The City of Worcester

Memorandum

Date: September 16, 2024; Revised October 4, 2024

Re: **36 Butler Street (MBL 10-043-00012) – Special Permit & Variance Application**

Map 1: Residential Housing Stock Composition

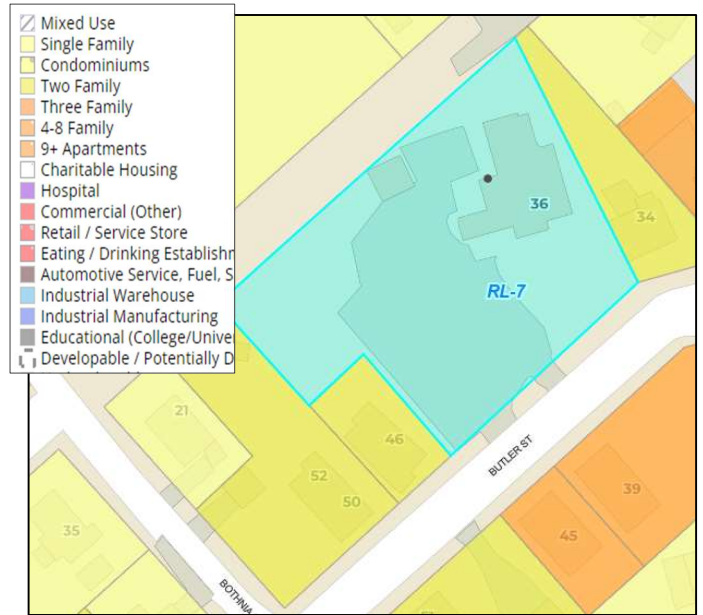
The subject property is located just outside the Quinsigamond Village neighborhood on Butler Street and was previously a funeral home (see Map 1).
